# ICE SHIELD SUSTAINMENT KIT

# Ice Shield Sustainment Kit

Ice Shield Technical Drawings

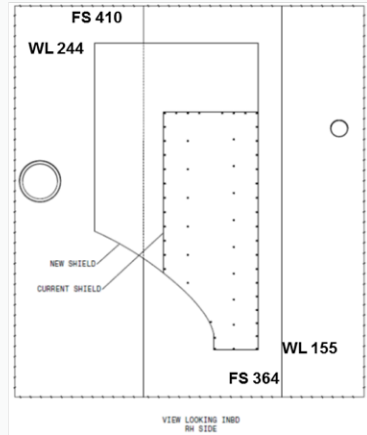
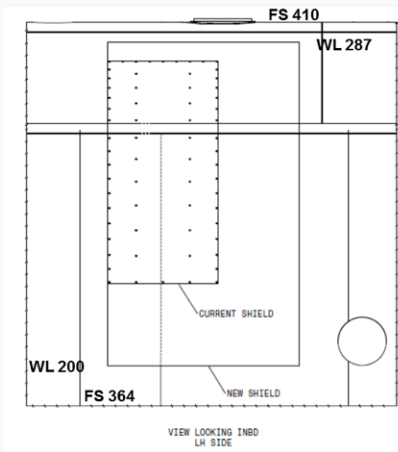
The improved Ice Shield will include a larger and thicker ice shield — 20 inches wider and 26 inches longer on the left hand side. The right is 20 inches wider and 27 inches longer, with both shields increasing in thickness from 0.040 to 0.071 inches of the same material and applies for fielded C-130J aircraft through Serial Number 5793.
